**Transportation Related Agency Correspondence for App. 5 and 6 – updated through November 2016**

**TECHNICAL MEMORANDUM  
Methodology for Transportation Impact Analysis (TIA)  
for Comprehensive Development Master Plan (CDMP) Amendment**

**Subject: American Dream Miami & The Graham Project  
Transportation Impact Analysis for Comprehensive Development  
Master Plan (CDMP) Amendment – December 22, 2015**

Figure 1 Map, Project Location and Existing Roadways

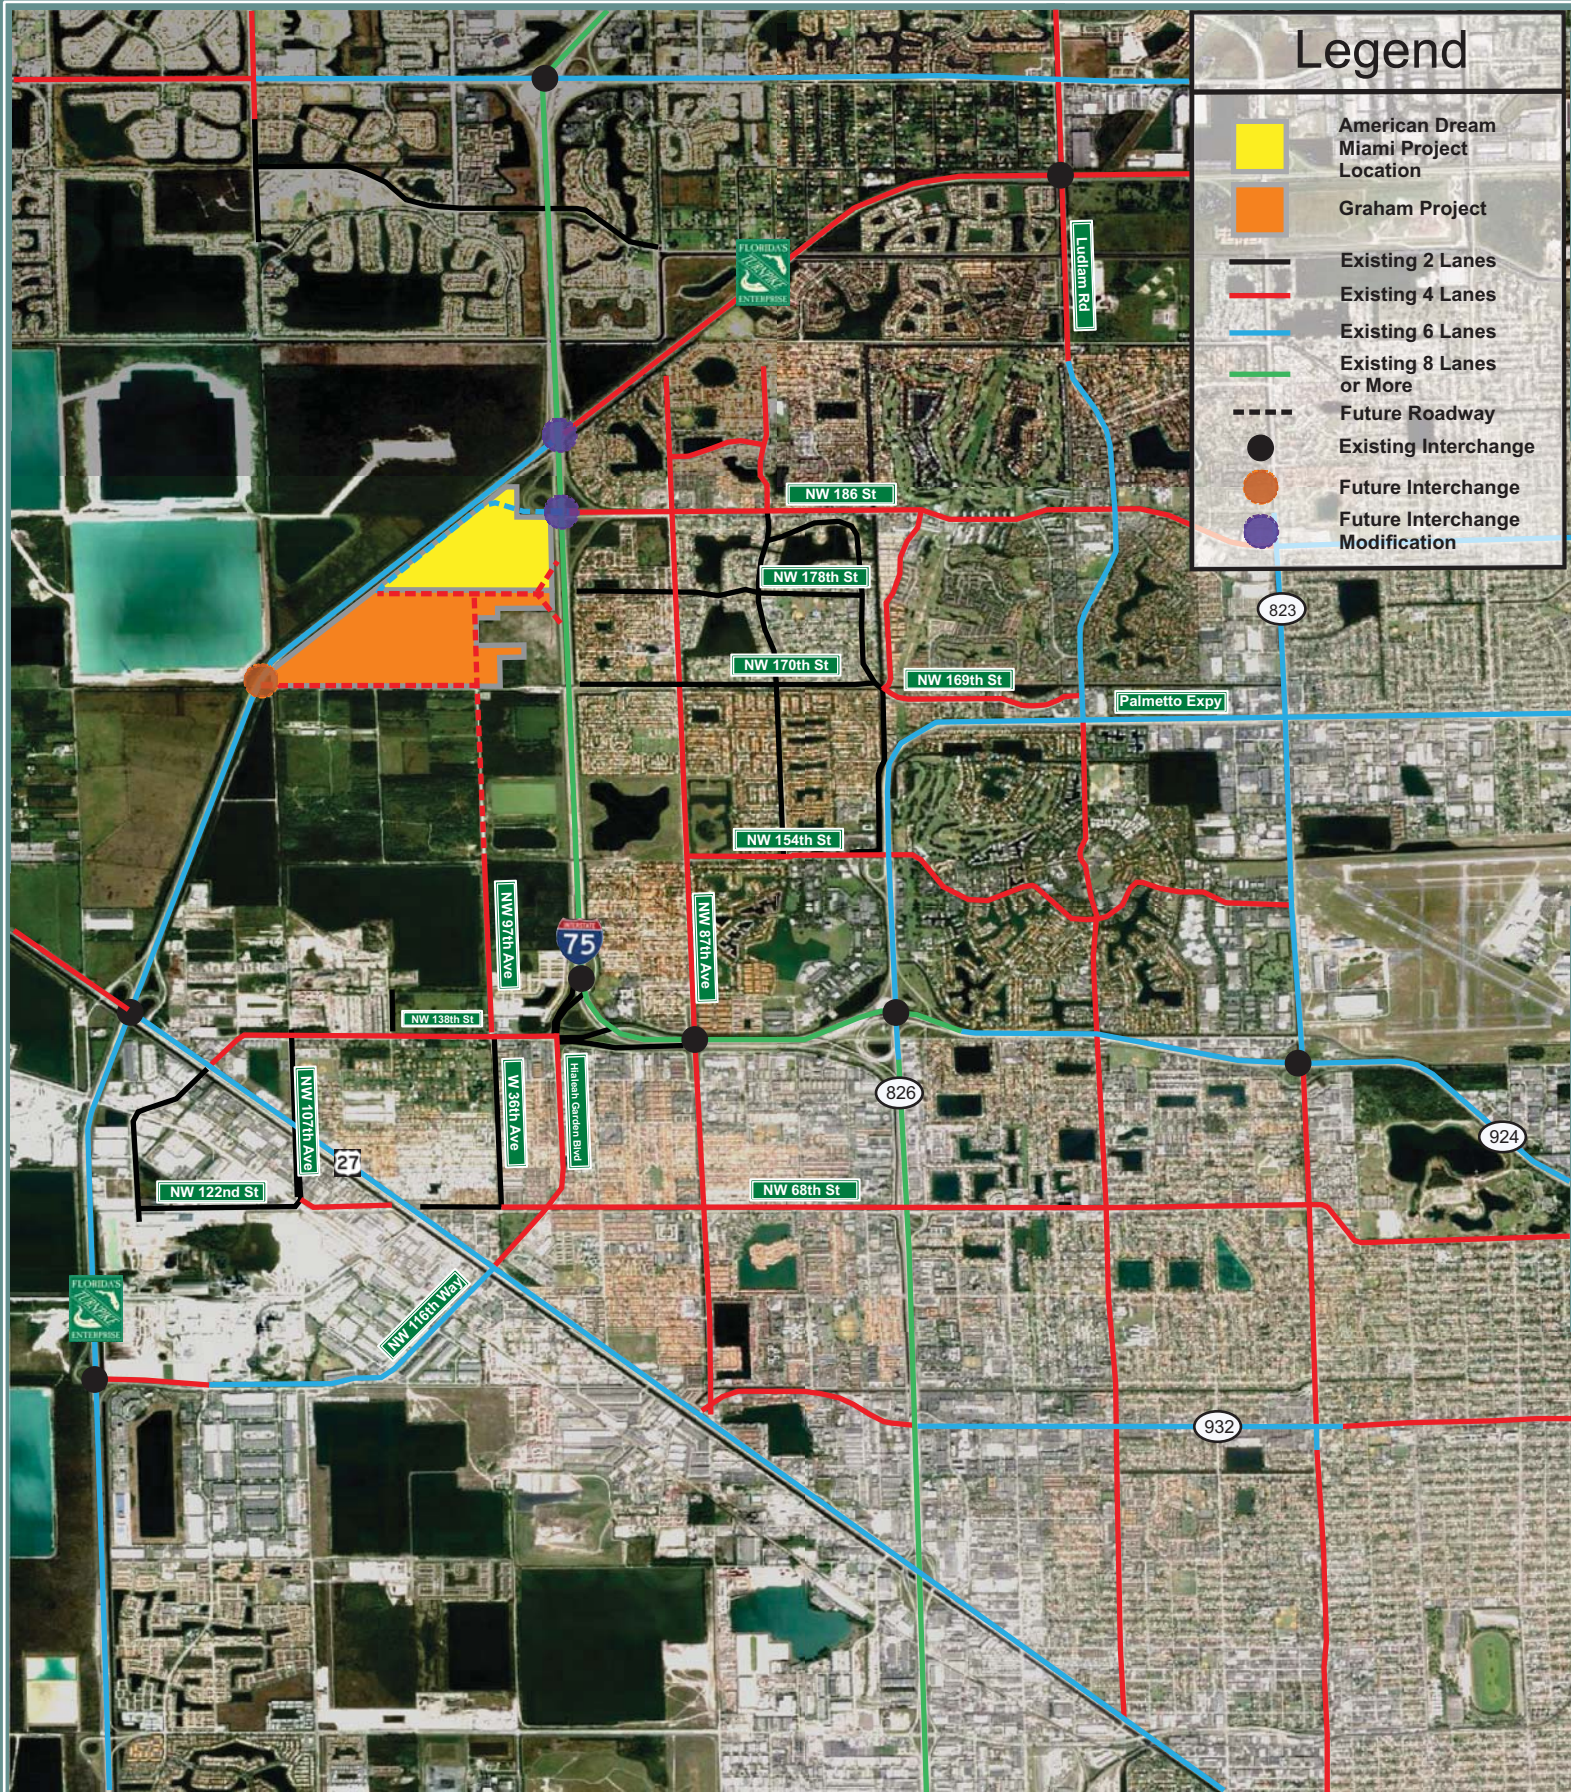
- Map must show all roadway improvements proposed for each of these two projects, such as NW 102 Avenue as indicated on Figure 2 Map.
- Some existing interchange locations are incorrect. For example, the interchanges at the HEFT and NW 67 Avenue and at I-75 and NW 87 Avenue do not exist. The interchange at I-75 and NW 87 is a planned future improvement. Please revise map accordingly.

**The interchanges will be added to Figure I-1.**

## Preliminary Access Plan

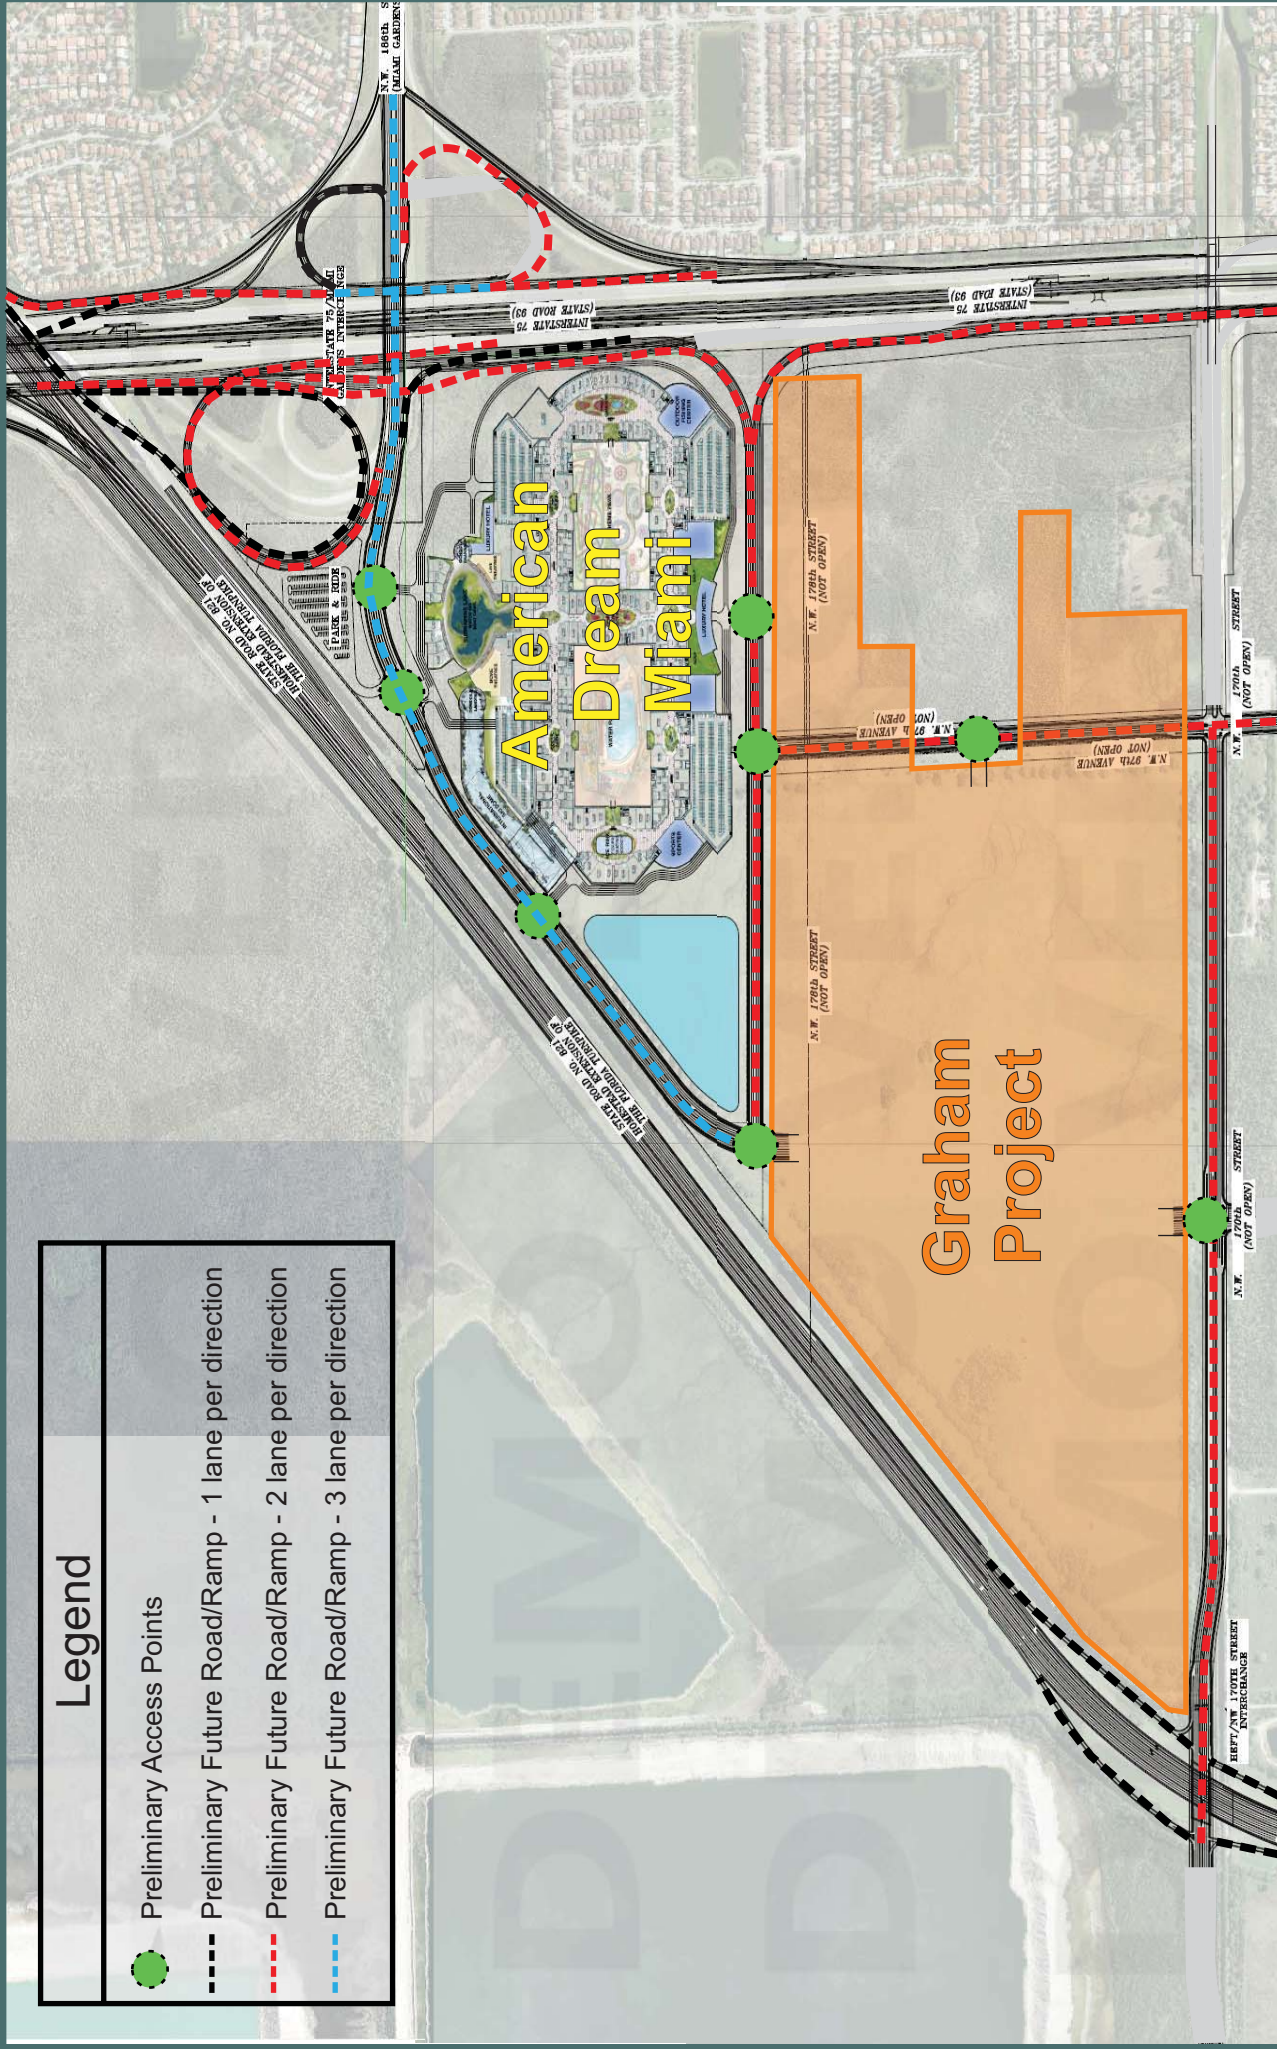
Figure 2 Map, Preliminary Access Plan

- Show all the planned roadway improvements proposed within the application site for the Graham project, such as NW 102 Avenue.

**Figure I-2 does include the proposed park and ride facility but is shown in small print. To more clearly highlight the facility, an additional label will be added to the figure.**
